RE: FC - Complaint Construction Survey  
Sozo Family Care Home  
2757 Mewborn Church Road  
Snow Hill Greene County  
FID #080236 FCL-040-009

You have provided DHSR-Construction Section with an unacceptable Plan of Correction.

- Tag # C116 - One deficiency was cited under this tag set give detailed information on what actions will be done to make the correction(s) as well as an estimated completion date for the listed deficiency.

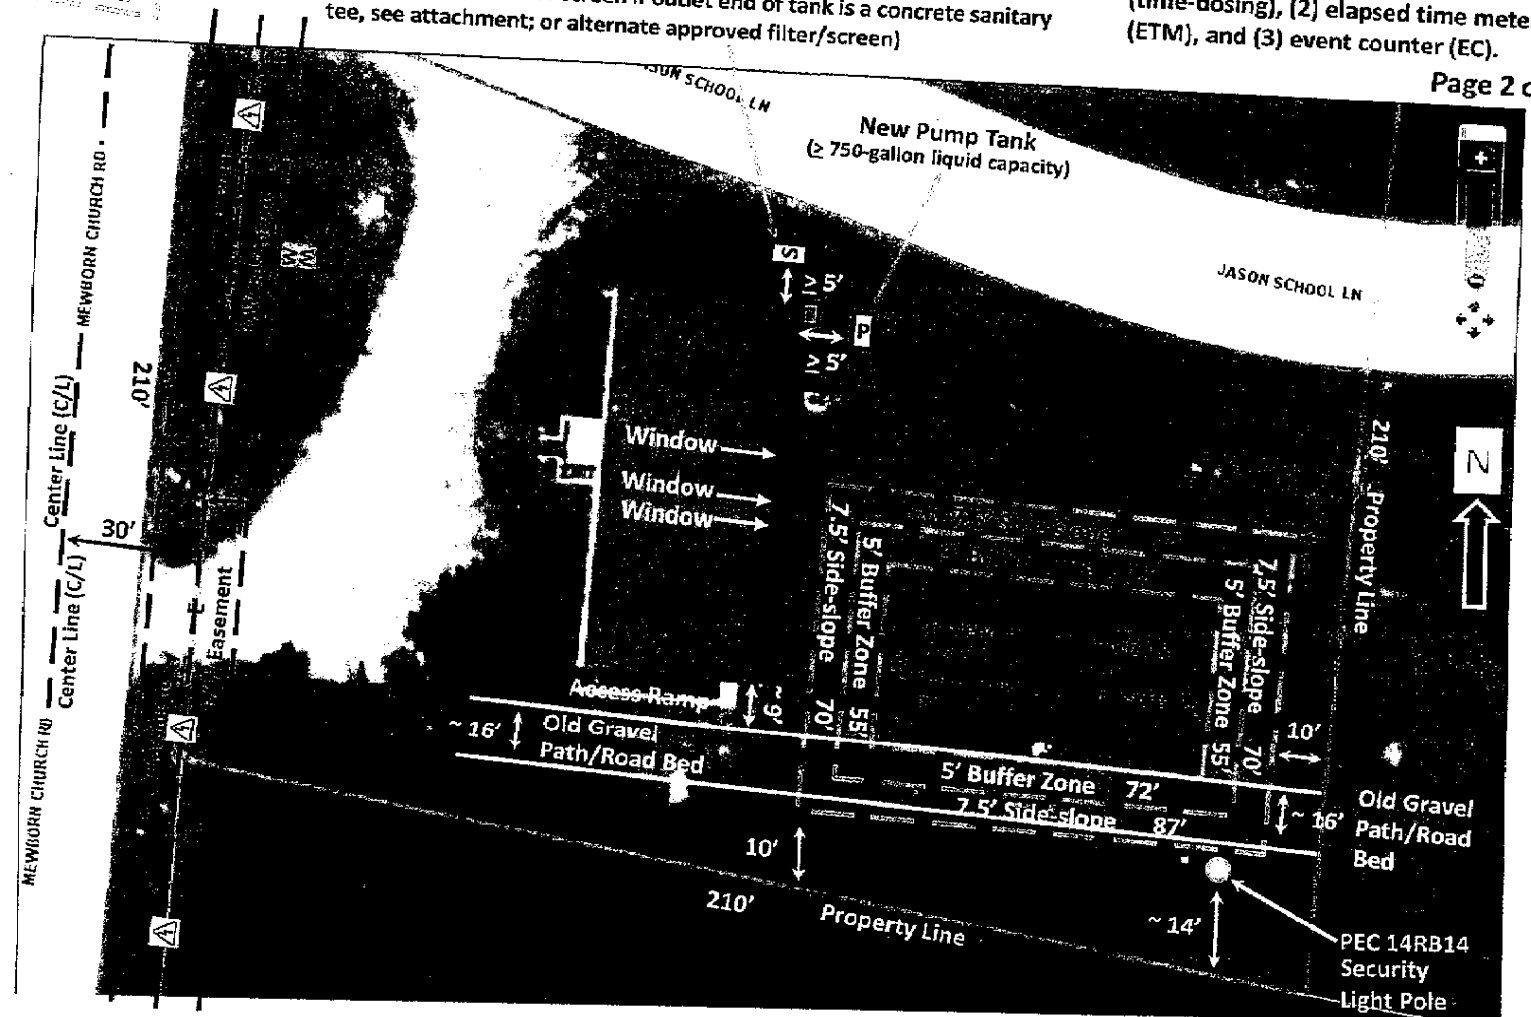
(must verify tank is  $\geq 1,000$ -gallon liquid capacity, is located at least 5-feet from building foundation, and structurally sound & watertight; if so, require installation of an approved/suitable effluent filter- (e.g., STF-110 Series effluent filter or screen if outlet end of tank is a concrete sanitary tee, see attachment; or alternate approved filter/screen)

Must have at least the following features: (1) programmable timer (time-dosing), (2) elapsed time meter (ETM), and (3) event counter (EC).
